City of Miami Beach
Last Completed Item Reviews Across All Submittals

Permit Type: Building - Commercial **Work Class:** Alteration (w/o Phased) **Application Date:** 05/22/2020 **Status:** Approved
Address: 235 WASHINGTON AVE **Permit:** BC2013662

Re: Response to City Comments.

Sobe Hostel
235 Washington Ave.
Miami Beach, Florida

Date	JUNE. 08, 2020	Sheet No.
Scale	AS INDICATED	A3.00
Project	1967

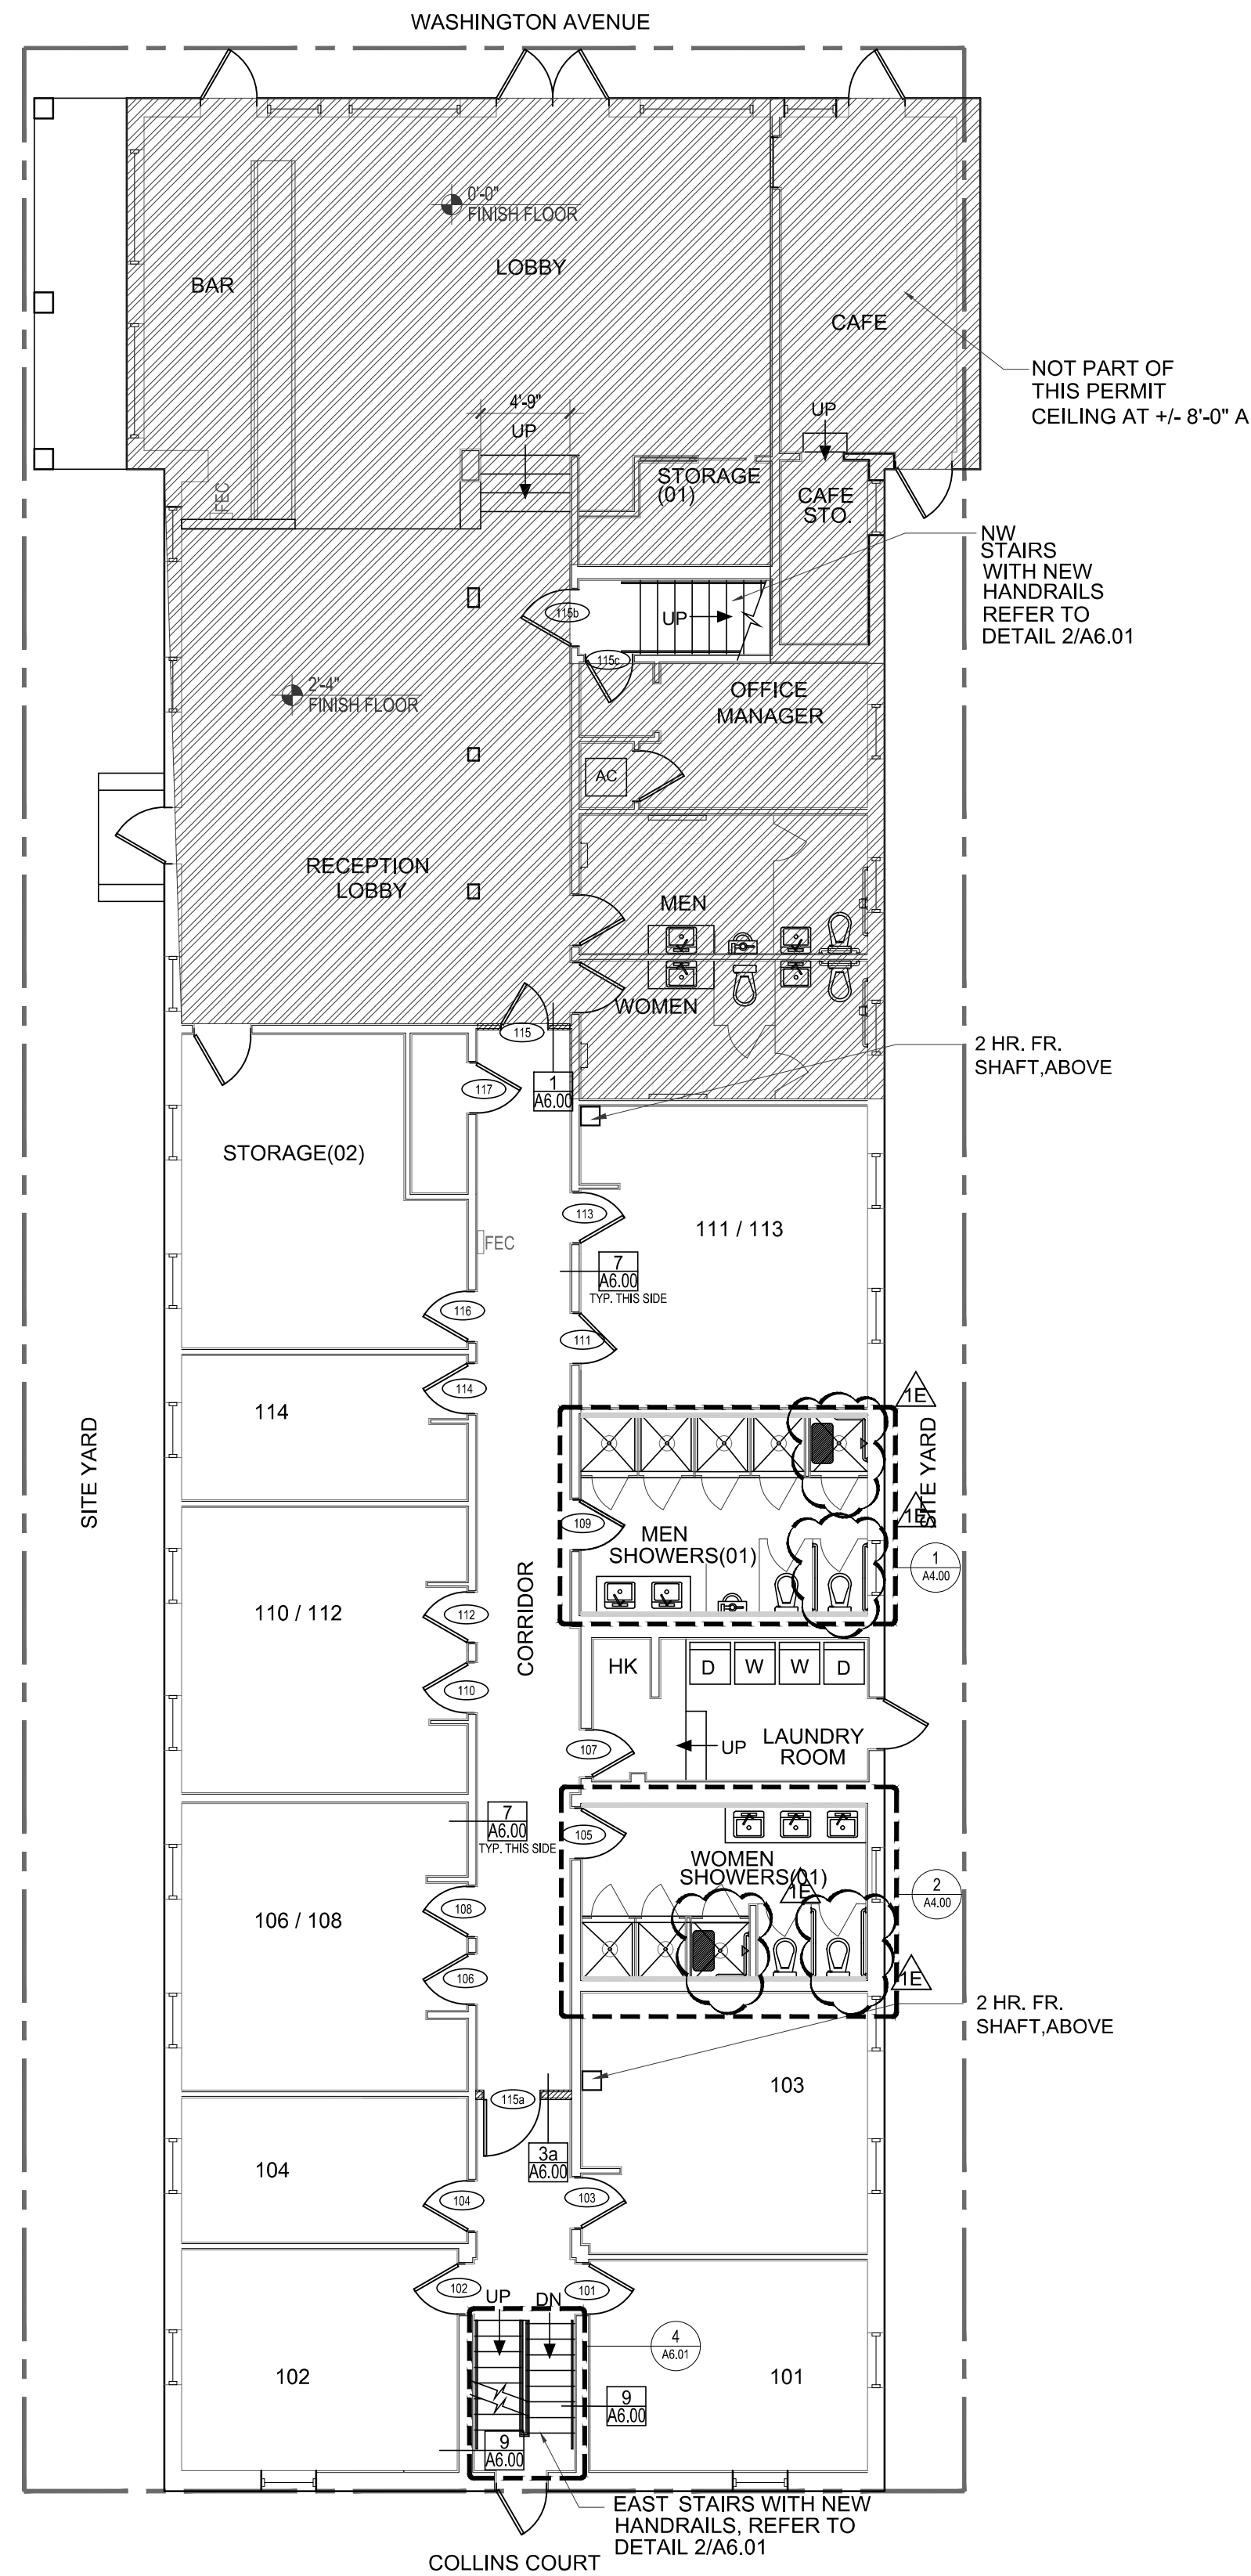
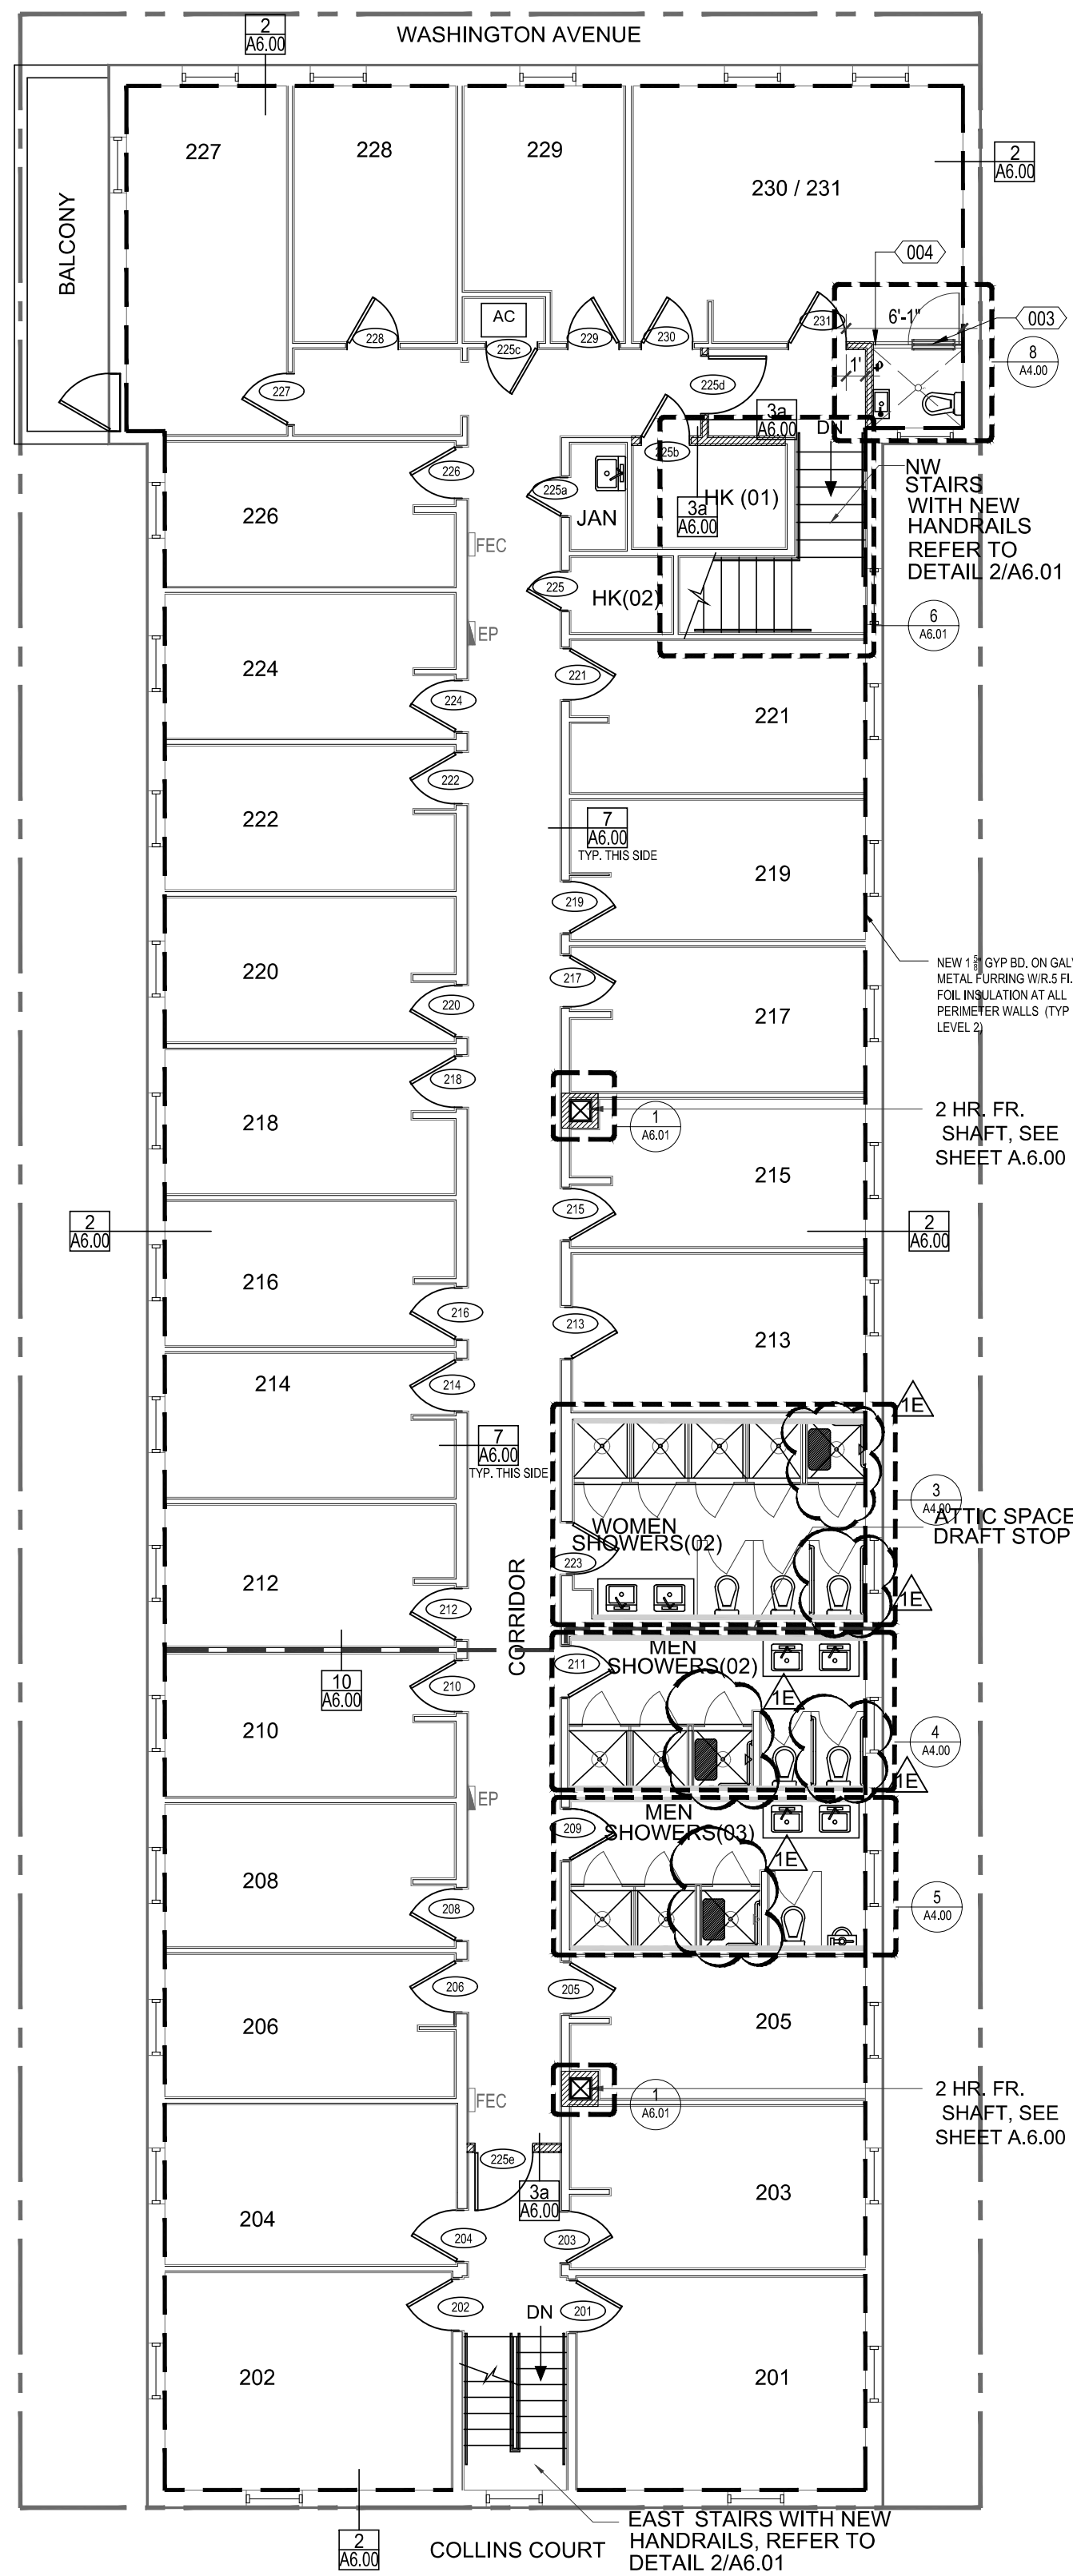
2. Tag all walls/partitions to verify compliance with the fppc 6th ed 6.1.14.4.1(a)(b) typical for all floors

3. Plans shows a manager's office that opens into the exit enclosure that does not comply with the ffpc 6th ed 7.2.2.5.3

4. Plans show the first floor with an area that is hatched, clarify if out of scope of work

KKAID Response: New partitions are tagged on this sheet with reference to details on sheet A6.00

KKAID Response: Room condition are existing to remain and not part of this permit for renovation

KKAID Response: Cross hatched areas are existing and not part of this renovation
